# Memorandum

Subject: Westridge North Townhomes – Site Development Permit: SDP16-00001

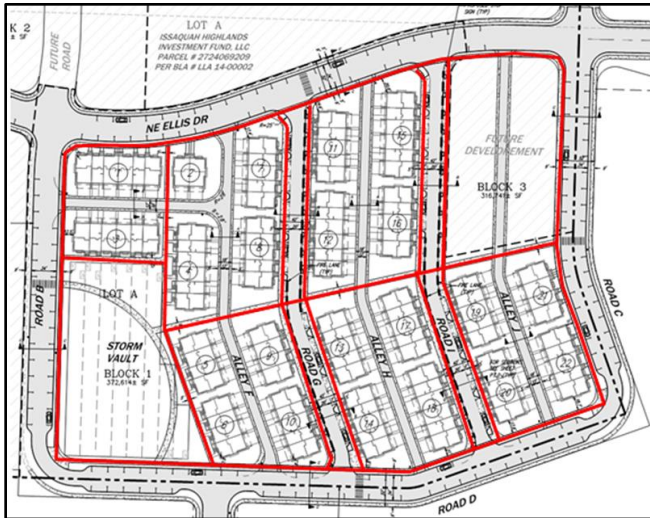
***Issues:*** Will all sidewalks and trails be publicly accessible and how will their respective designs convey that all users are "welcome"? How will pedestrians be protected at the various pedestrian crossings within the project?

A. All sidewalks and trails within the project will be publicly accessible as they located on public right-of-way, or because Public Pedestrian Access Easements are required.

*The above excerpt from Sheet P3 of the Staff Report plan drawings shows decorative pedestrian crossings as required per Condition 9.*

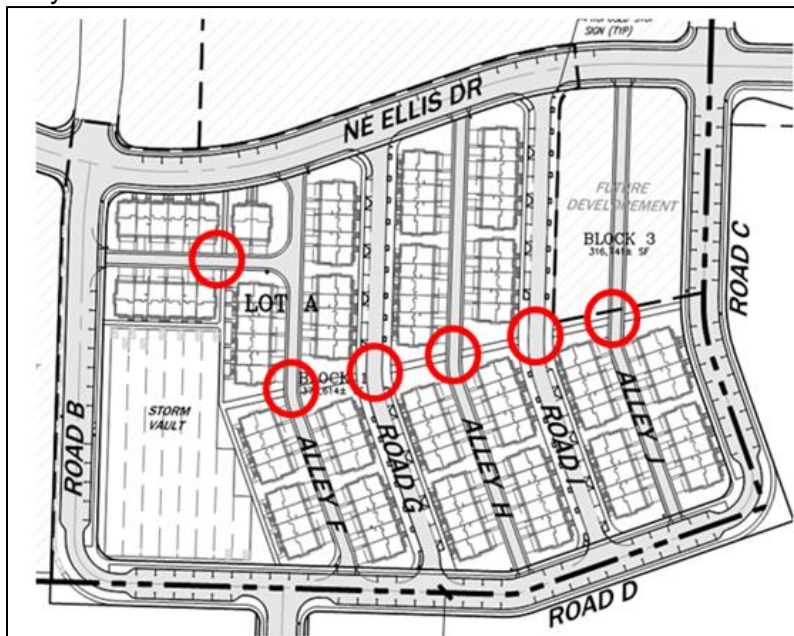
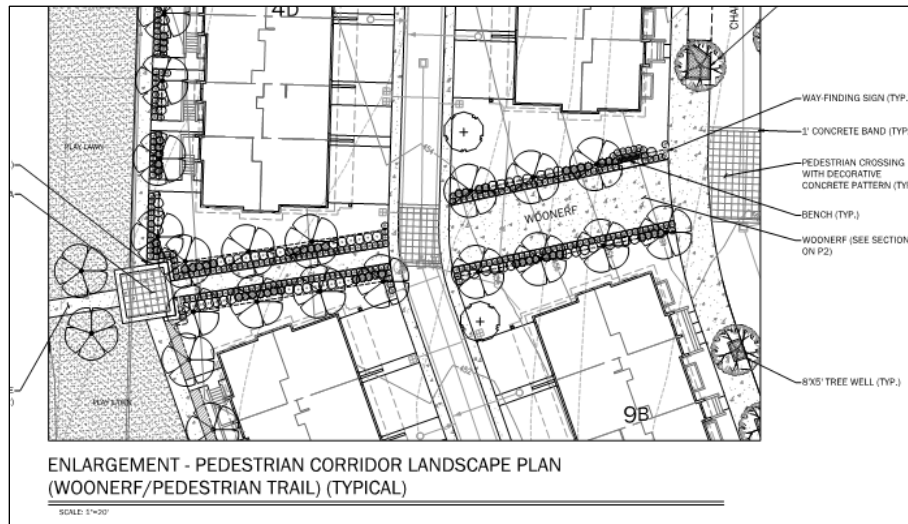
The image below shows the locations where pedestrian crossings occur at the streets and alleys internal to the site.

Per Conditions 9 and 41 below, the crossings as shown above will have design characteristics and landscape restrictions to make pedestrians visible to drivers and to indicate to drivers that are at a pedestrian crossing.

**Condition 9:** Designated pedestrian paths and trails which cross vehicular routes, drives, access routes, etc... shall be designed to draw the driver's attention to the possible presence of pedestrians. This condition would be met, for example, through the use of pedestrian tables, changes in material (e.g. concrete, pavers; not solely paint or striping), etc... Emergency vehicle routes shall not use raised crosswalks. This will be reviewed with Utility Permits.
